Subject: Notice to Designers No. 10R1 - Special Track Work: Crossover and Turnouts; Tunnel Cross Section Reduction

This memorandum establishes the revised guidelines for the Regional Teams to follow in the Preliminary Engineering Design with respect to universal crossover spacing, speed of crossovers and turnouts, and Tunnel Cross Section Reduction.

**SPACING BETWEEN CROSSOVER AND TURNOUT**

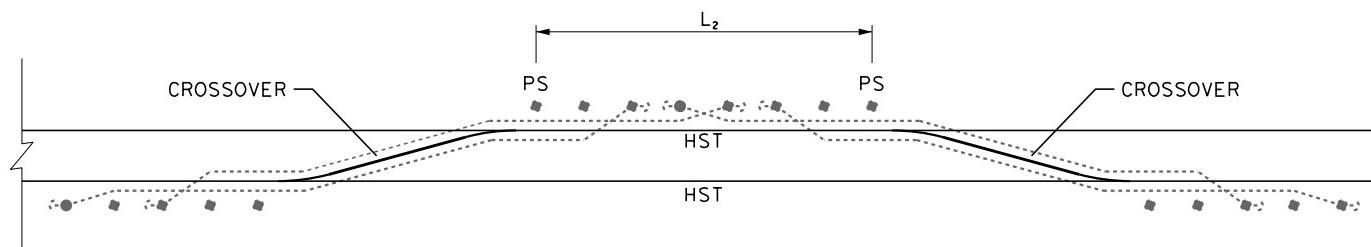
3. Spacing Between Facing Adjacent Points of Switch on Main Tracks
  - a. The distance between two facing points of switch of adjacent crossovers and the distance between the point of switch of a turnout facing an adjacent point of switch of a crossover shall adhere to the following spacing requirements:

- Desirable distance between two high-speed (60 mph or faster) points of switch: 1400'
    - Minimum distance between two high-speed (60 mph or faster) points of switch: 1000'

- Desirable distance between two low-speed (55 mph or slower) points of switch: 600'
    - Minimum distance between two low-speed (55 mph or slower) points of switch: 400'

- Desirable distance between high-speed and low-speed points of switch: 1000'
    - Minimum distance between high-speed and low-speed points of switch: 700'

1. THESE REQUIRED SPACING ARE RESERVED FOR TERMINATING THE OCS WIRES AND THE DOWN-GUY INSTALLATION.
2. THESE GUIDELINES APPLY TO HIGH-SPEED (60 MPH AND FASTER) MAINLINE CROSSOVERS AND TURNOUTS WHEN INSULATED OVERLAP WIRING IS USED FOR SECTIONALIZATION.

3. FOR LOW-SPEED (55 MPH AND SLOWER) CROSSOVERS AND TURNOUTS ON THE MAINLINE TRACK, SECTION INSULATOR CAN BE USED FOR SECTIONALIZATION. THE PREFERRED L<sub>1</sub> AND L<sub>2</sub> SHALL BE 600 FT, AND MINIMUM L<sub>1</sub> AND L<sub>2</sub> SHALL BE 400 FT. THESE GUIDELINES ARE NOT APPLICABLE TO THE YARD TURNOUTS.

4. FOR A LOW-SPEED (55 MPH AND SLOWER) CROSSOVER OR TURNOUT ADJACENT TO A HIGH-SPEED (60 MPH AND FASTER) CROSSOVER OR TURNOUT ON THE MAINLINE TRACK, THE PREFERRED L<sub>1</sub> AND L<sub>2</sub> SHALL BE 1000 FT, AND MINIMUM L<sub>1</sub> AND L<sub>2</sub> SHALL BE 700 FT. THESE GUIDELINES ARE NOT APPLICABLE TO THE YARD TURNOUTS.

PREFERRED: L<sub>1</sub> ≥ 1400'  
MINIMUM: L<sub>1</sub> ≥ 1000'

PREFERRED: L<sub>2</sub> ≥ 1400'  
MINIMUM: L<sub>2</sub> ≥ 1000'

**TYPICAL TRACK LAYOUT**  
INTERMEDIATE STATION WITH HIGH-SPEED TURNOUTS

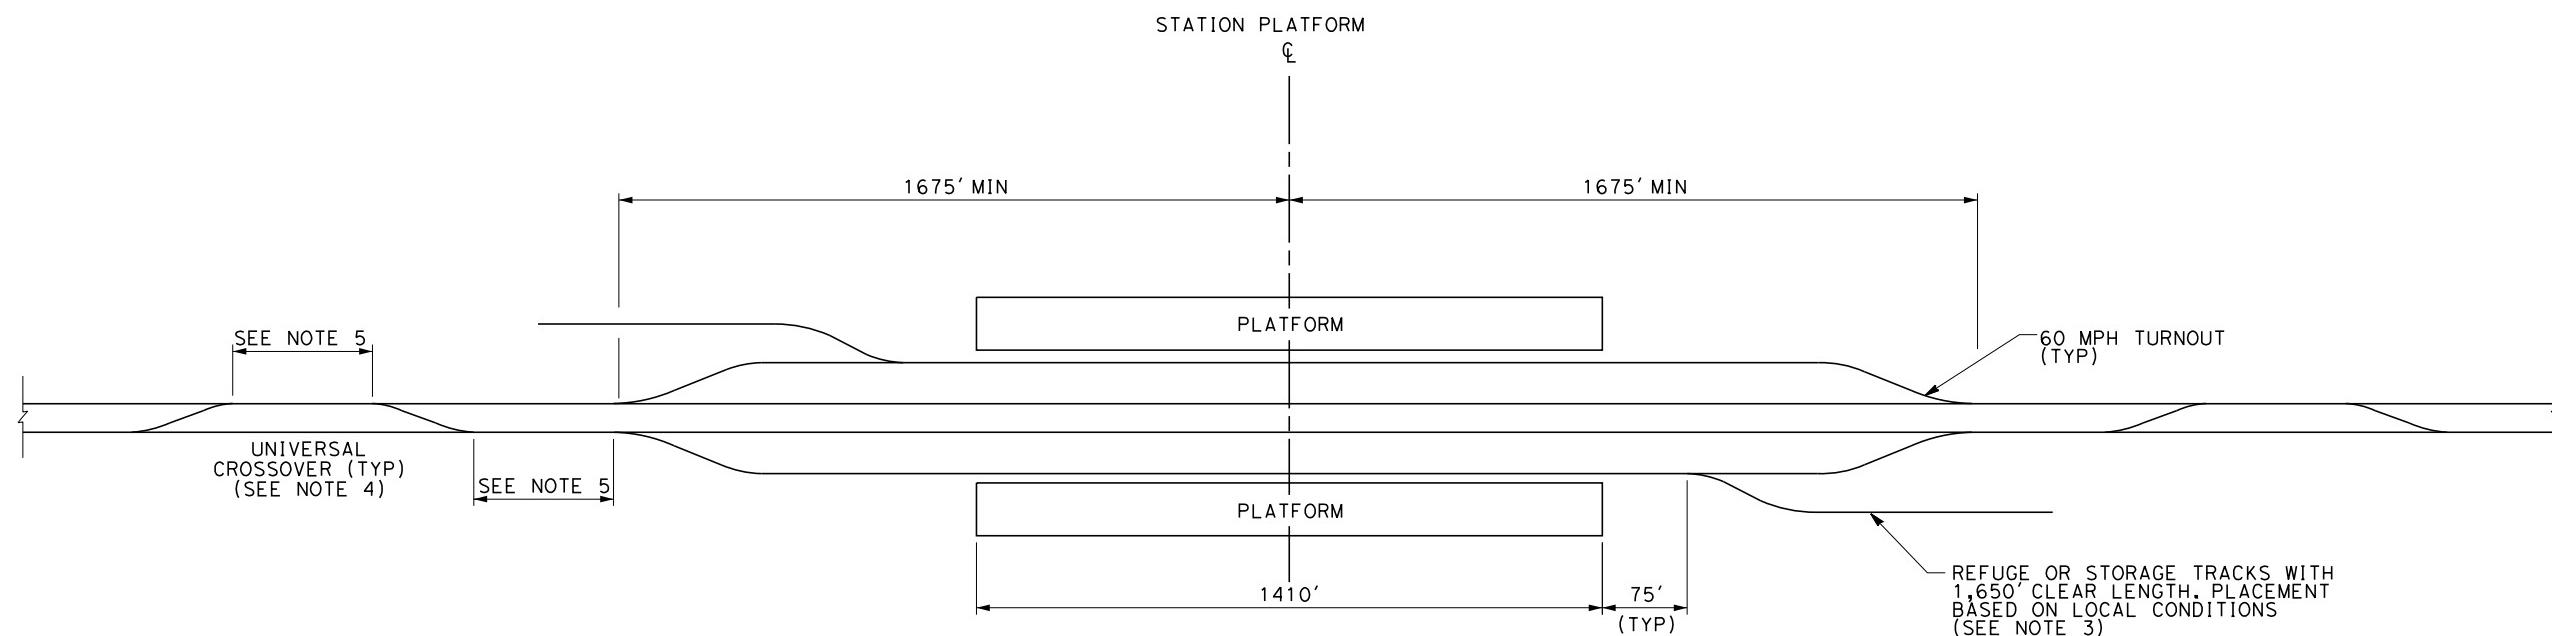
2. Lower Speed Station Turnouts:
  - a. Reduce size of Turnouts from 110 mph to 60 mph.
  - b. Reducing the speed of the station turnouts is in conjunction with the recommendation to reduce the speed of the universal crossovers and increase their spacing.

- c. The station platform track between entry turnout and the exit turnout along the main track shall have a 3,350 foot minimum length centered symmetrically on the midpoint of the station platform.

1. 60 MPH DESIGN OF STATION TRACK, TURNOUTS.
2. GRADE  $\leq 0.25\%$  MAX.
3. 3300' MINIMUM TOTAL REQUIRED FOR REFUGE OR STORAGE TRACKS. REFUGE OR STORAGE TRACKS CAN BE LOCATED IN ANY QUADRANT OF THE STATION.
4. PROVIDE UNIVERSAL CROSSOVERS BETWEEN MAIN TRACKS AT EACH SIDE OF STATION TRACKS.
5. FOR POINT OF SWITCH SPACING, SEE NTD 10 "SPACING BETWEEN CROSSOVERS AND TURNOUT" DRAWING.
